CASE REFERENCE HGY/2023/1836

Sam Barker
26 Tilson Road
London N17 9UY

REAR ELEVATION 26 TILSON ROAD

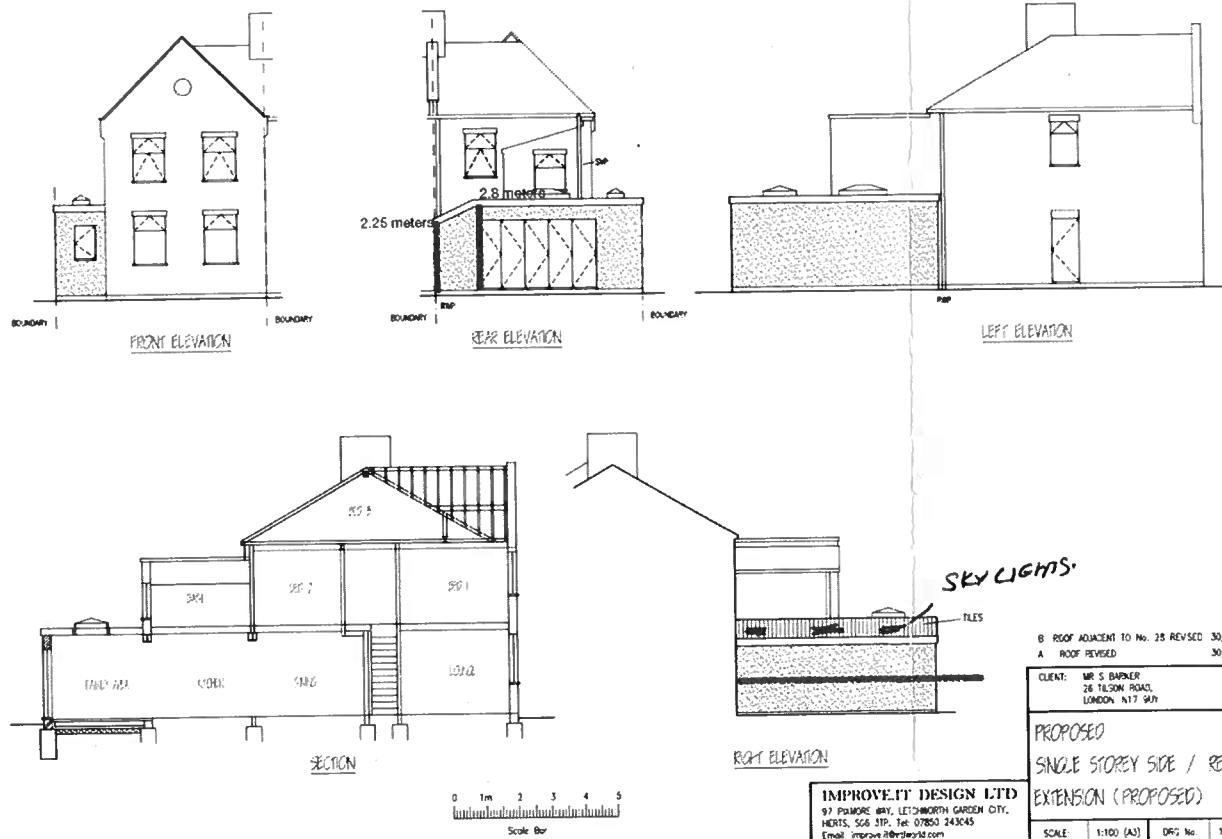
In order to comply with planning we had to build our extension to the maximum height of 2.8 meters

We then had to angle the extension down to the height 2.25 meters in order to not block no 28's light. SEE DRAWINGS

We would insist that the same courtesy was shown to us .
